DOCUMENT 00 90 00
ADDENDUM

ADDENDUM NO. [2] **Date: February 24, 2021**

RE: WESTERN TECHNICAL COLLEGE
SPARTA PUBLIC SAFETY EXPANSION
11177 COUNTY HWY A
SPARTA, WISCONSIN 54656
HSR PROJECT NO. 20028

This Addendum consists of [5] pages, [1] Revised Bid Form, [1] specification section [21] 30 x 42 drawings and [1] prior product approval.

1 FIRST FLOOR DEMO PLAN - AREA A
1/8" = 1'-0"

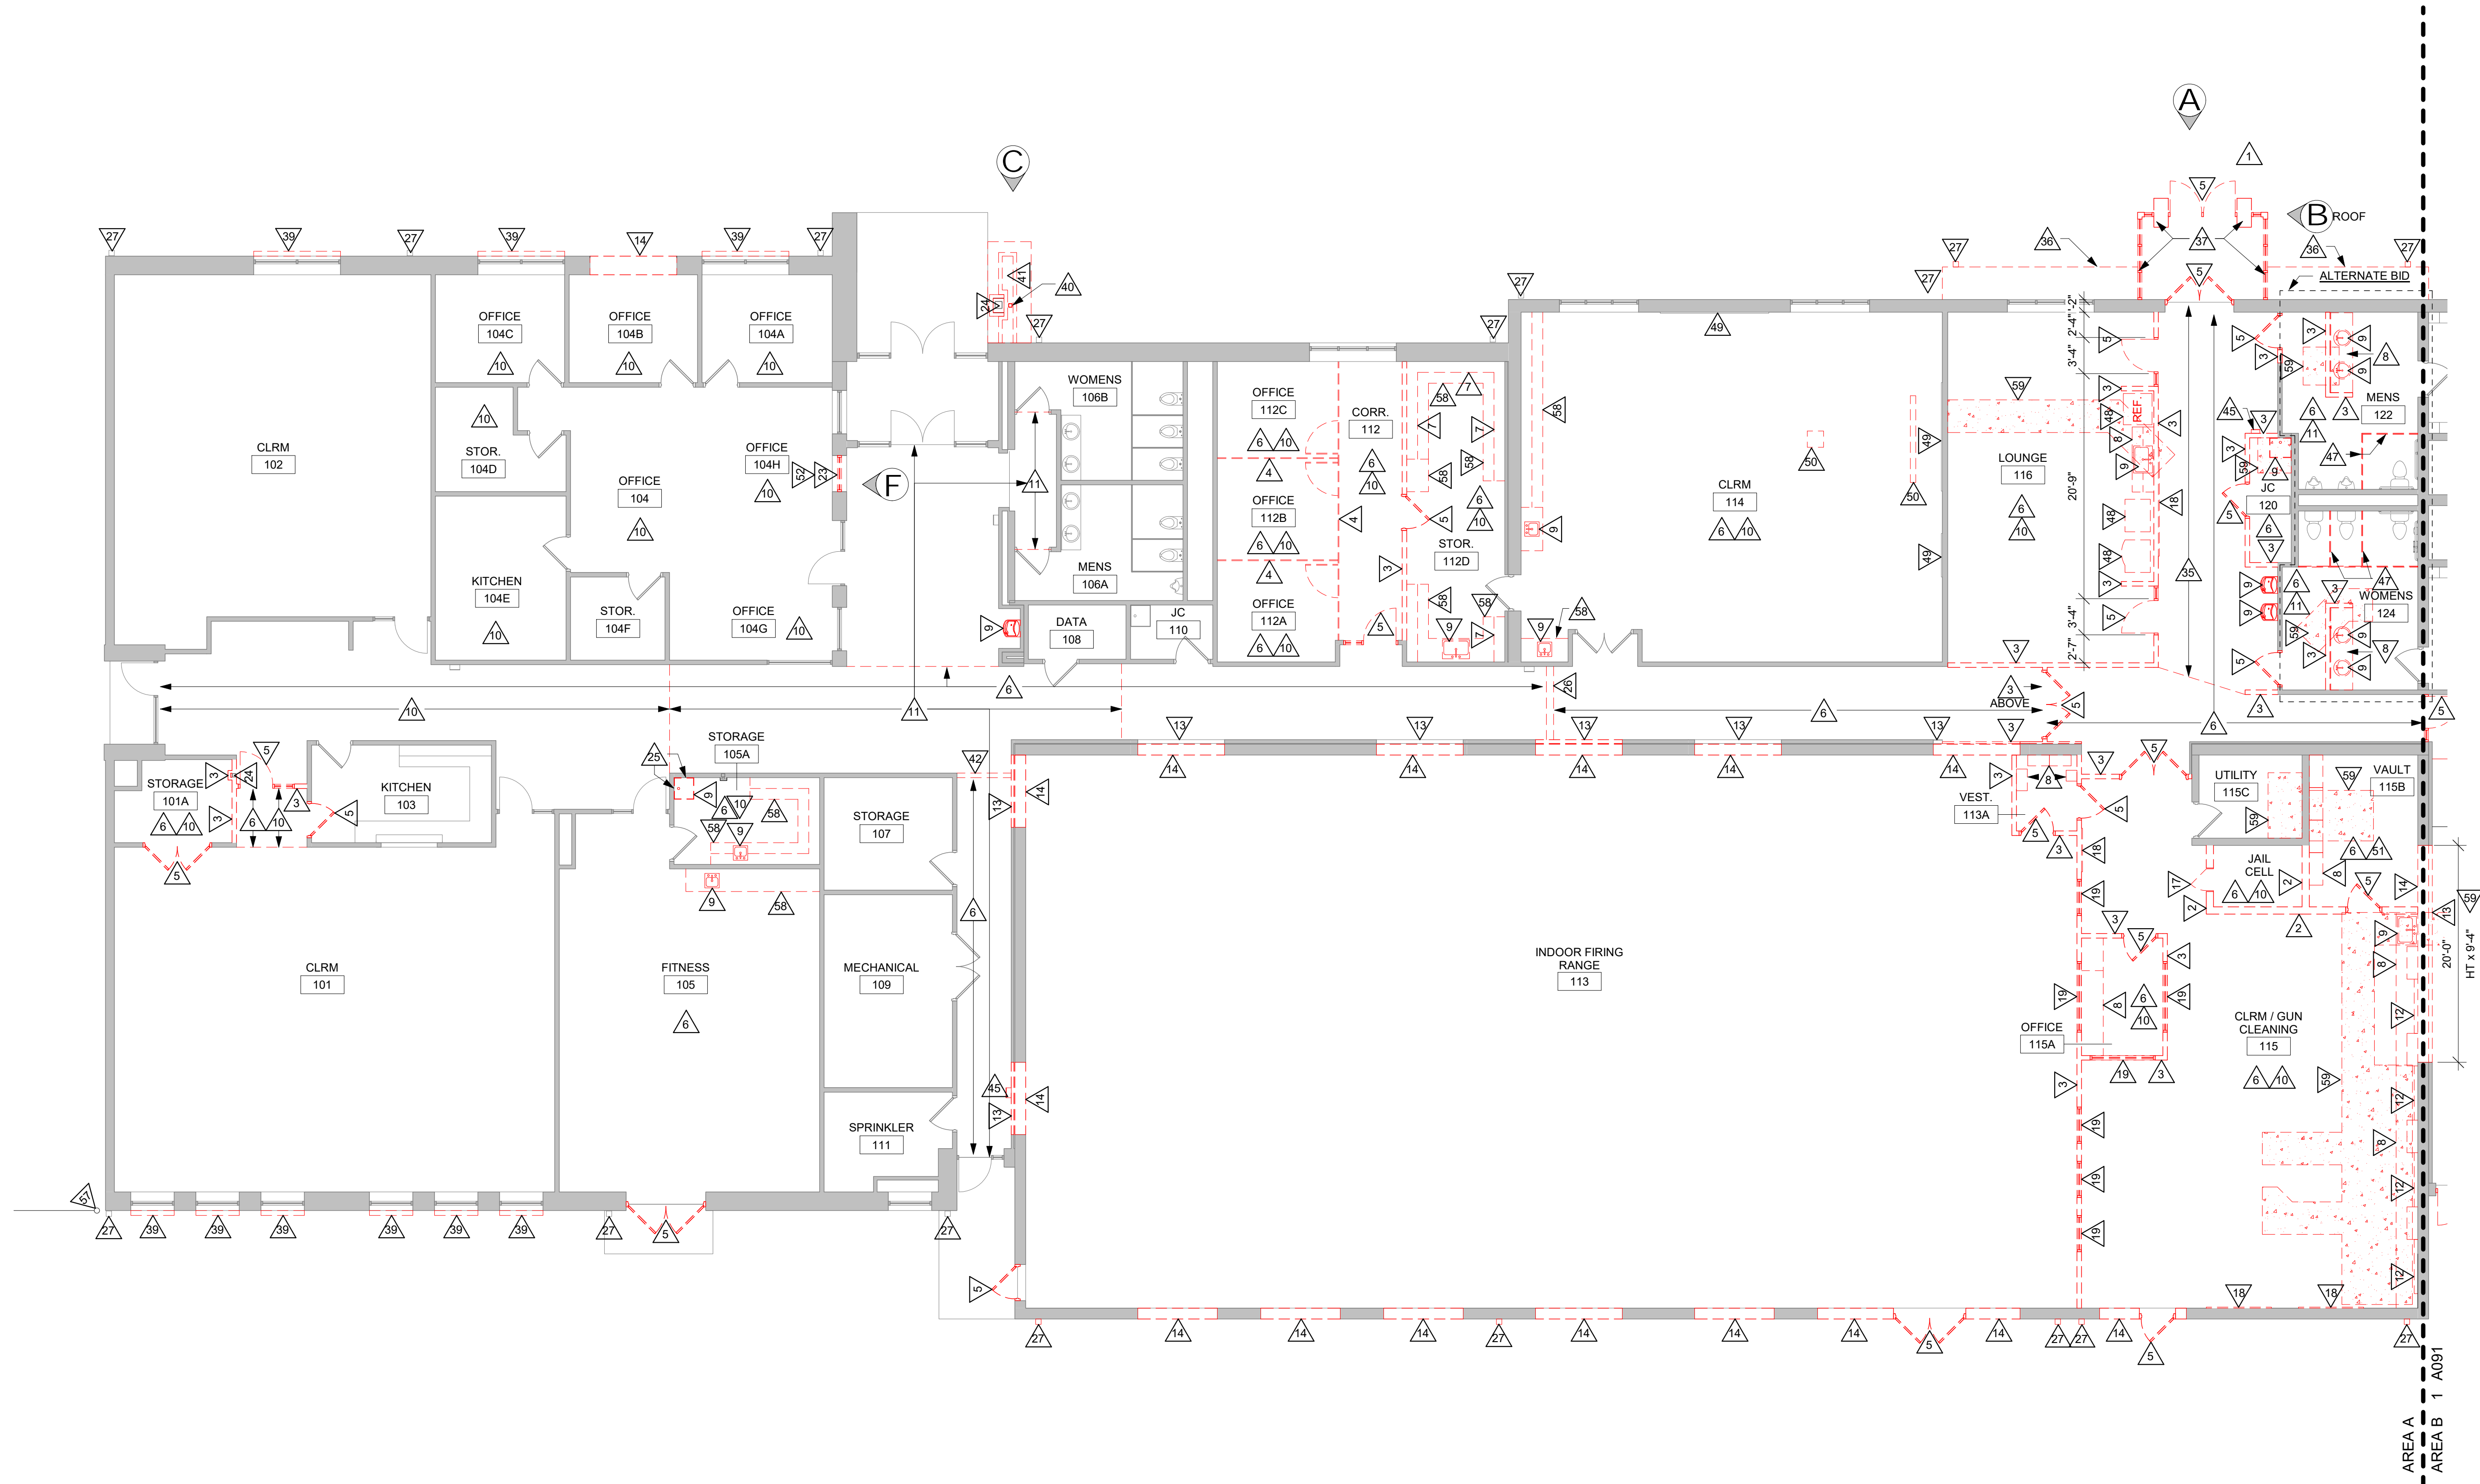
13. Sheet A090 FIRST FLOOR REMOVAL PLAN – AREA A 30 x42 attached hereto
 - a. Revisions clouded on Drawing
 - b. Added general note to remove and reinstall outlet covers in corridors.
14. Sheet A091 FIRST FLOOR REMOVAL PLAN – AREA B 30 x42 attached hereto
 - a. Revisions clouded on Drawing
 - b. Added general note to remove and reinstall outlet covers in corridors.
15. Sheet A100 FIRST FLOOR PLAN – AREA A 30 x42 attached hereto
 - a. Revisions clouded on Drawing
 - b. Removal of projector screen from room 105.

1 FIRST FLOOR PLAN - AREA B
1/8" = 1'-0"

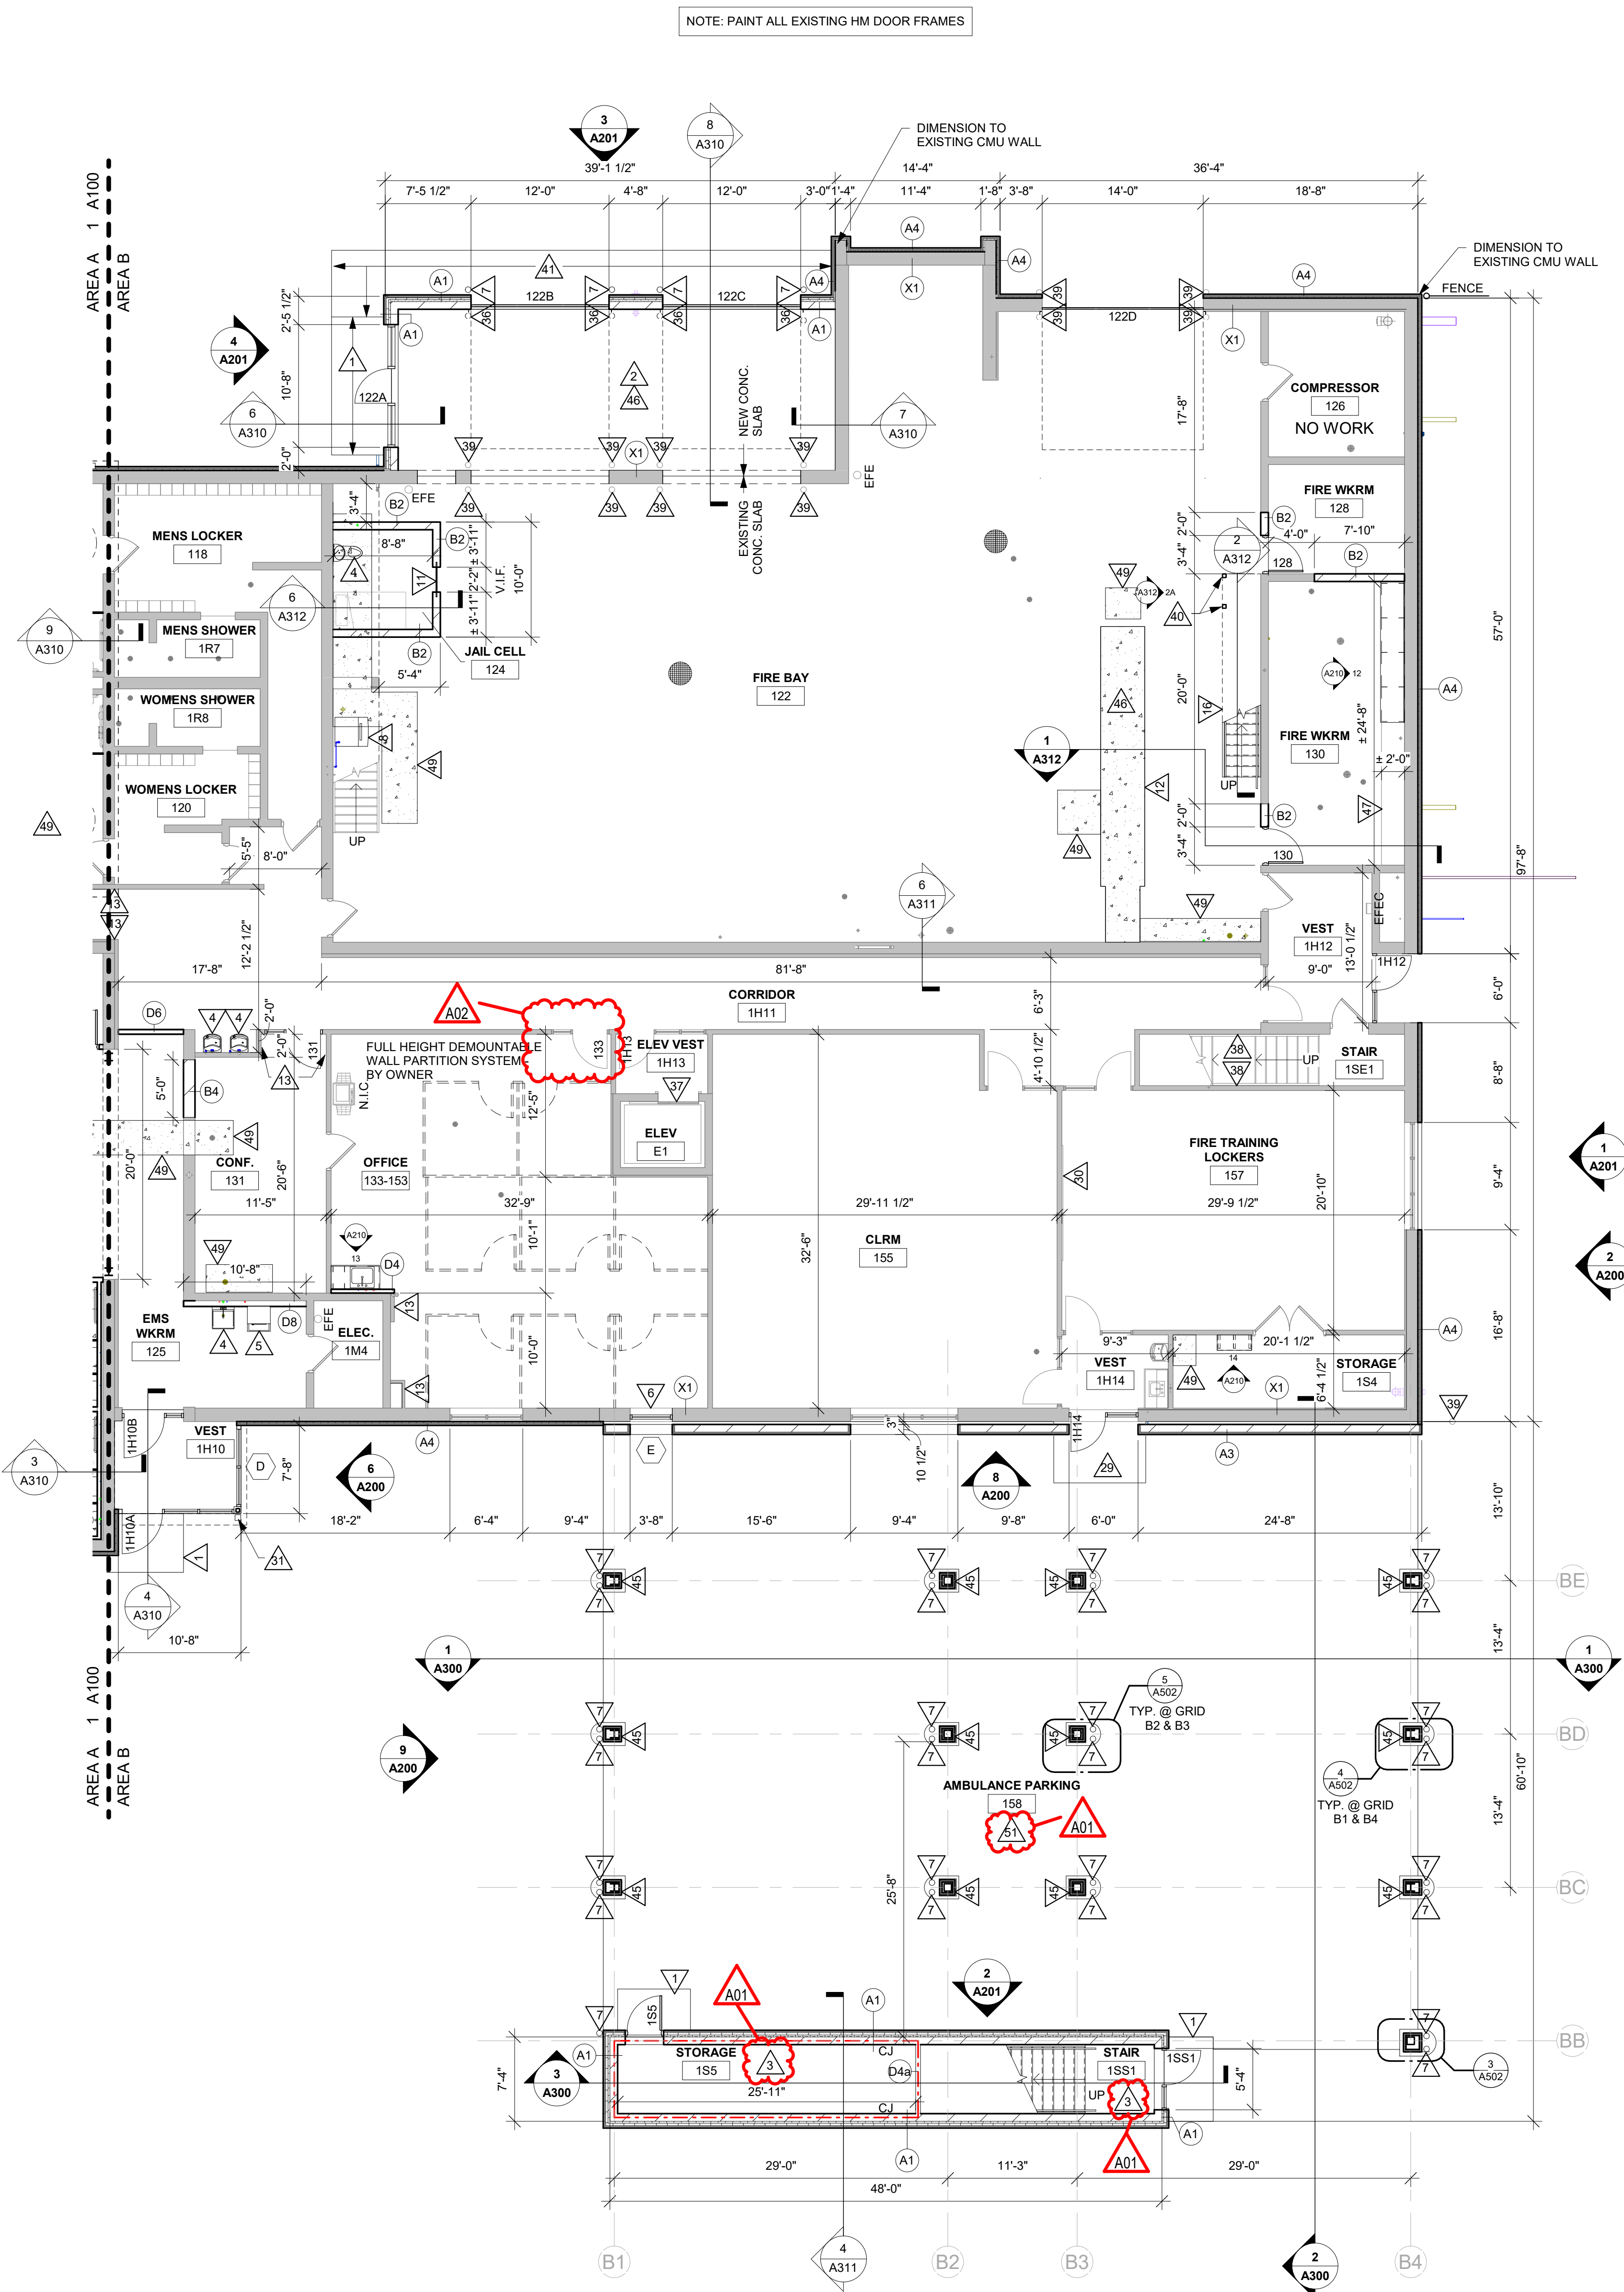
16. Sheet A101 FIRST FLOOR PLAN – AREA B 30 x 42 attached hereto
 - a. Revisions clouded in Drawing
 - b. Added door number to identify existing door 133.

A102

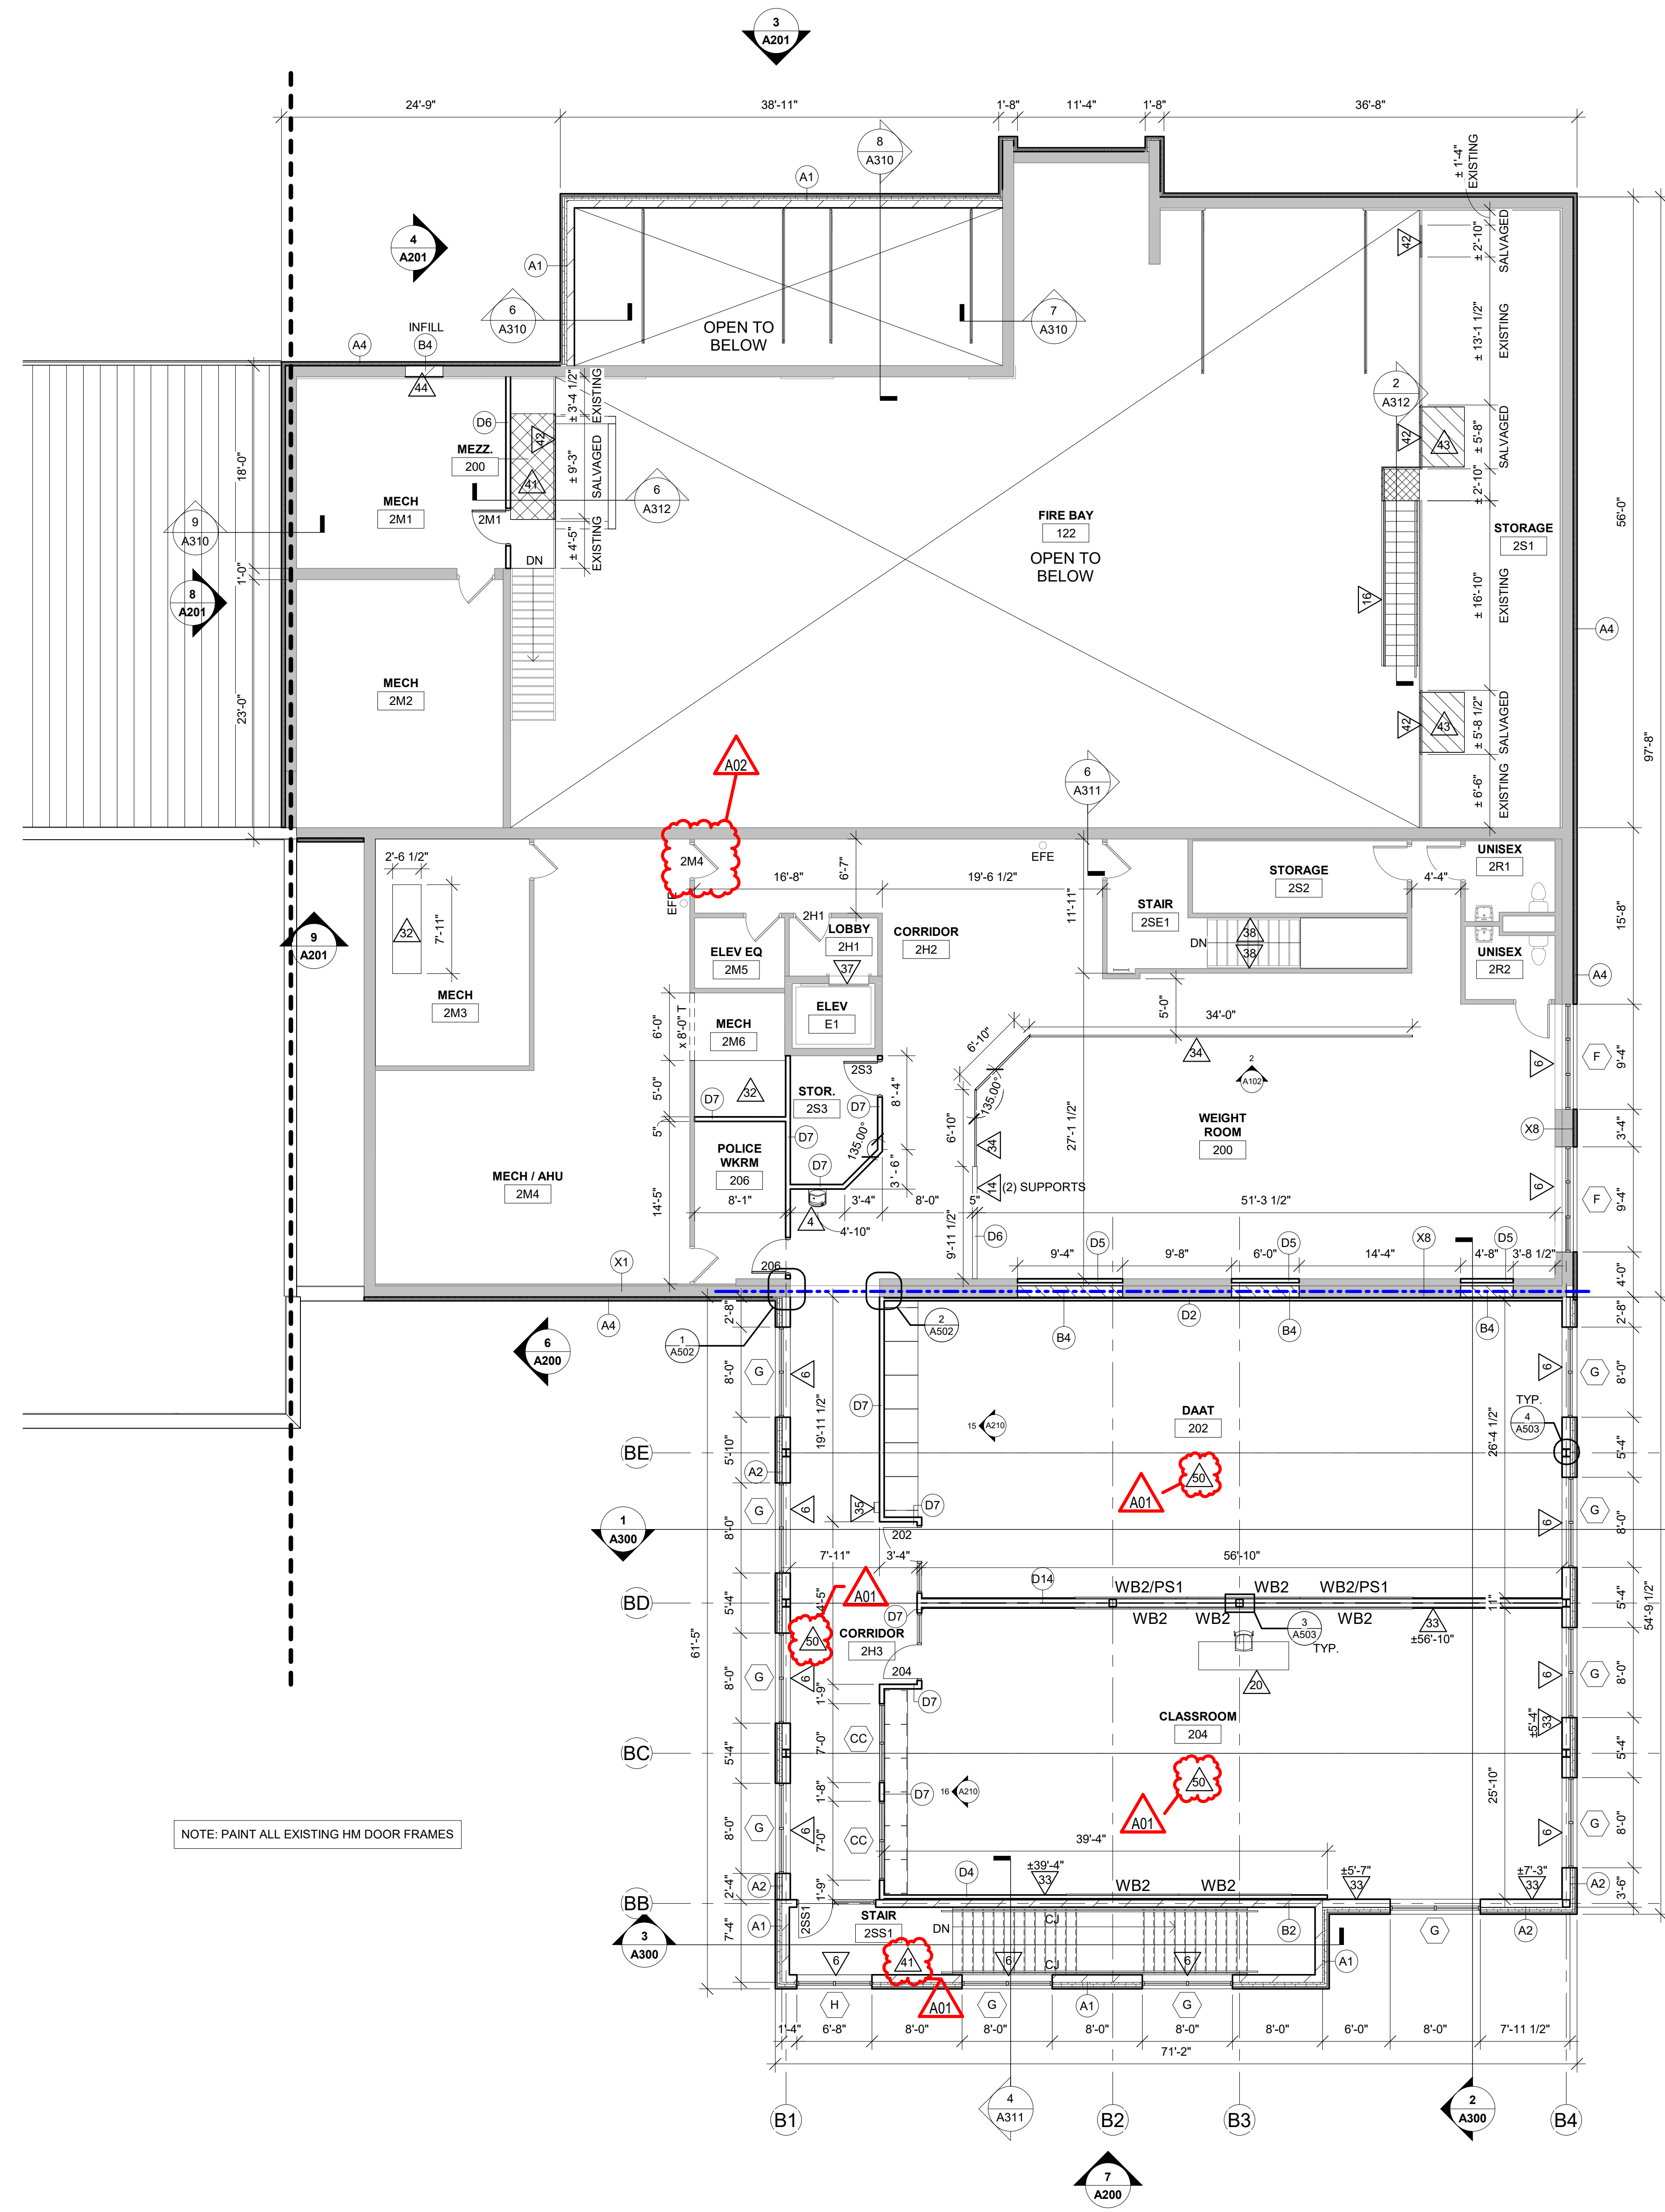
17. Sheet A102 SECOND FLOOR PLAN 30 x 42 attached hereto
 - a. Revisions clouded in Drawing
 - b. Added door number to identify existing door 2M4.
18. Sheet A110 FIRST FLOOR REFL CEILING PLAN – AREA A 30 x42 attached hereto
